Burlington Design Advisory Board

DESIGN ADVISORY BOARD Tuesday January 26, 2021 3:00 PM REMOTE MEETING

1. **21-0414CA/MA; 75 Cherry Street (FD6, Ward 3C) BTC Mall Associates, LLC**
Mixed use redevelopment of the former Burlington Town Center mall site.

To: The Design Advisory Board
From: Mary O'Neil, AICP, Principal Planner
RE: 75 Cherry Street; ZP21-0414CA
Date: January 26, 2021

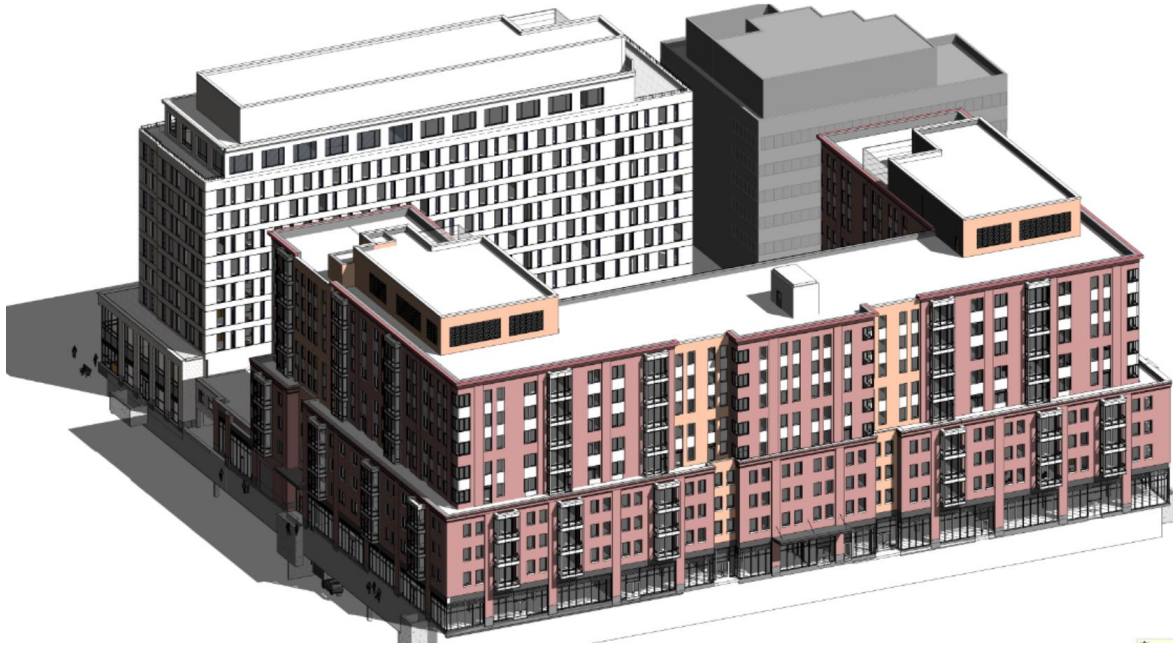
The building volume of the north residential building steps back at the 5th floor and is vertically accentuated with changes in the building plane, arrangement of windows, and introduction of varying primary materials. The roofline is accentuated with a bold cornice projection on different planes, breaking the massing up into readable building volumes. The cornice both caps the massing, and leads the eye down the street supporting and strengthening the street plane. The pedestrian level is enhanced with broad glazing to welcome and warm the streetfront energizing the pedestrian experience; strong material interplay delineates both building volume and division of segregate spaces. Vertical masonry piers draw the eye upward linking the lower pedestal to the upper, recessed stories.

St. Paul Street loading dock

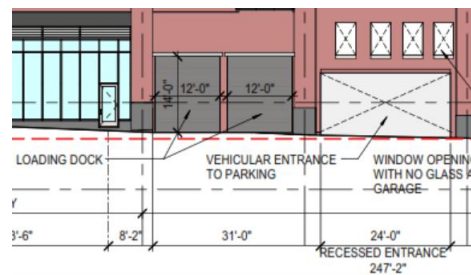
Loading and service overhead doors are not on the Primary Frontage, but on secondary Facades (St. Paul, Pine, and Bank Streets.) The applicant asserts that doors 12' in width may not be possible due to truck maneuvering clearances and the width of the newly planned streets. An additional complication is Natural Gas (Vt. Gas) at grade service. This requires areas of solid façade adjacent to St. Paul St. Meters will be located in special rooms within the docks and designed in conjunction with Vt. Gas to meet service requirements with minimal variation from the Form Based Code regulations.

The 20% allowable DRB relief would accommodate a door width of **14' 4^{13/16"}**.

Pine Street parking access, detail.

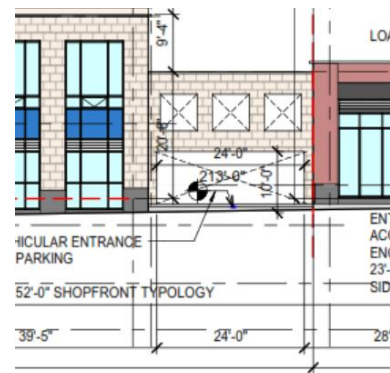
Although the plan set illustrates parking entries to be 24' in width, the applicant acknowledges that it may not be functionally possible. The two newly established streets (St. Paul, Pine) are quite narrow, and the Parking flow study for parking volumes in conjunction with the traffic study test the width limitation. A 20% maximum relief would offer an additional 4.8' width allowance or a maximum of **28' 9 ¹⁹/₃₂"**.
